TENNESSEE VALLEY AUTHORITY DOCKET NO. 50-259 (BROWNS FERRY NUCLEAR PLANT, UNIT 1) AMENDMENT TO FACILITY OPERATING LICENSE

Amendment No. 5 License No. DPR-33

CHANGE NO. 6

(BROWNS FERRY NUCLEAR PLANT, UNITS 1 AND 2)

2. Delete the existing Figure 3.5.1 Maximum Allowable Planar LHGR (page 150-b) and insert the revised Figure 3.5.1 attached hereto.

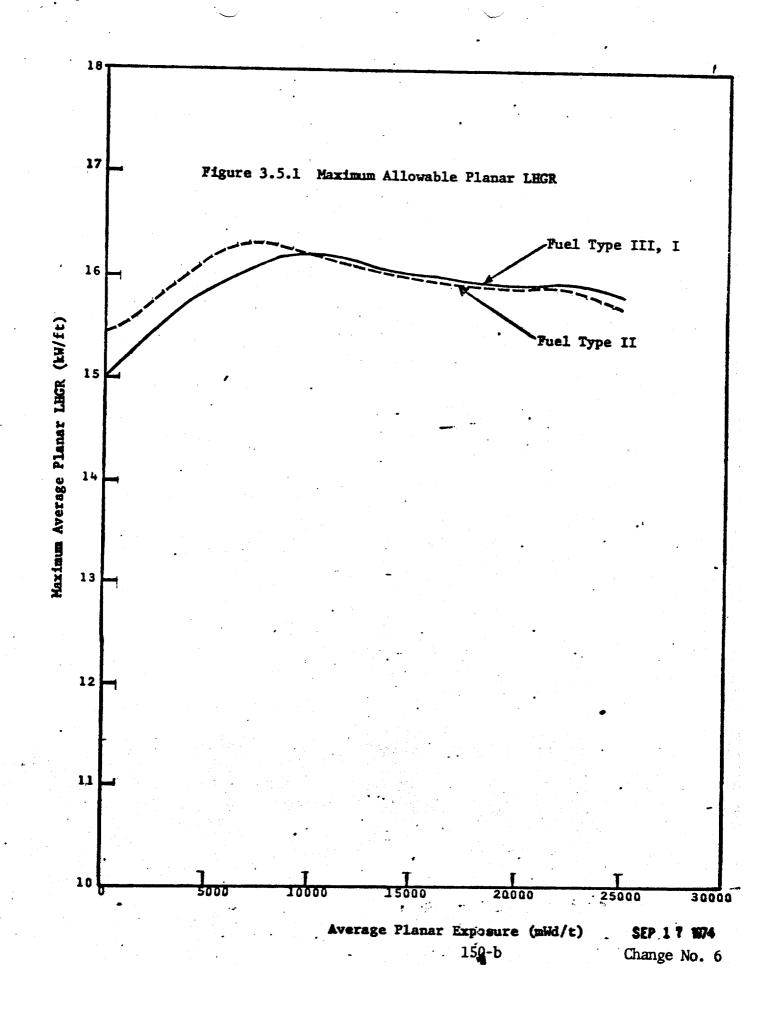
1. Delete the first paragraph on page 150 and replace with the following:

"The maximum average planar LHGR shown in Figure 3.5.1 is based on calculations employing the GEGAP III model described in the General Electric report NEDO - 20181, Revision 1. page 157."
